PAVEMENT MARKING PLAN
SOM CENTER RD. (S.R. 91) - STA. 17+50 TO STA. 30+00

LAK-2-3.32

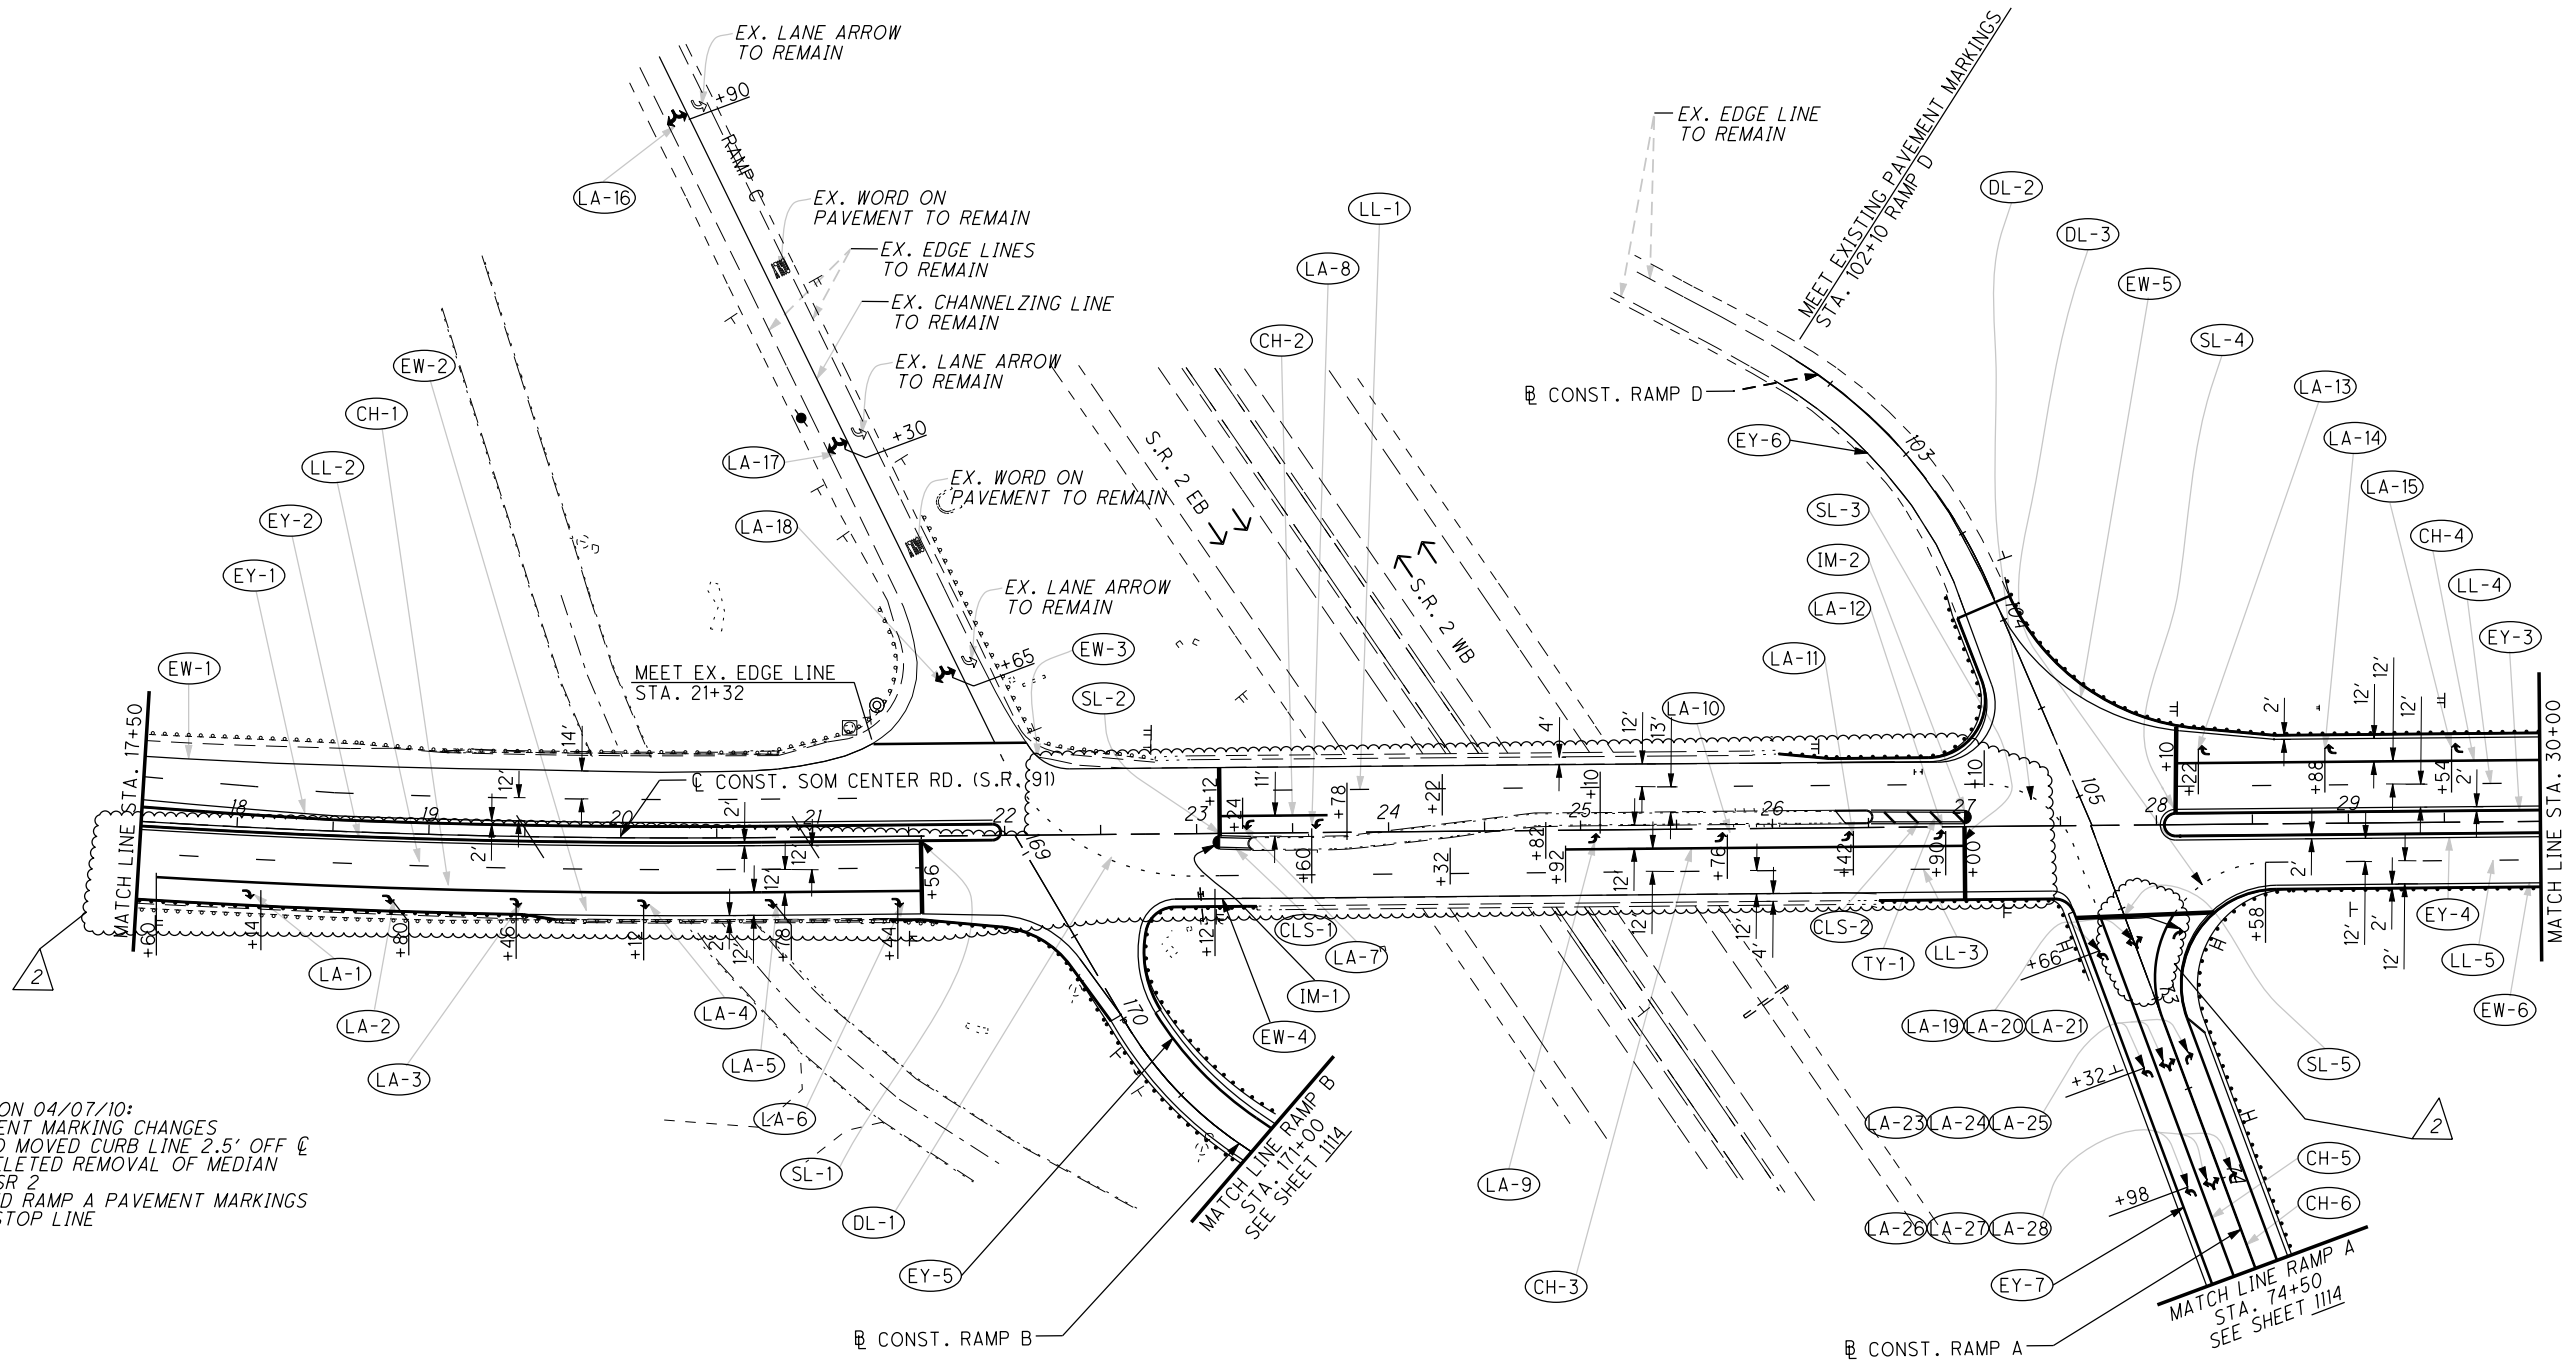
2 REVISION 04/07/10:
PAVEMENT MARKING CHANGES
DUE TO MOVED CURB LINE 2.5' OFF C
AND DELETED REMOVAL OF MEDIAN
OVER SR 2
REVISED RAMP A PAVEMENT MARKINGS
NEAR STOP LINE
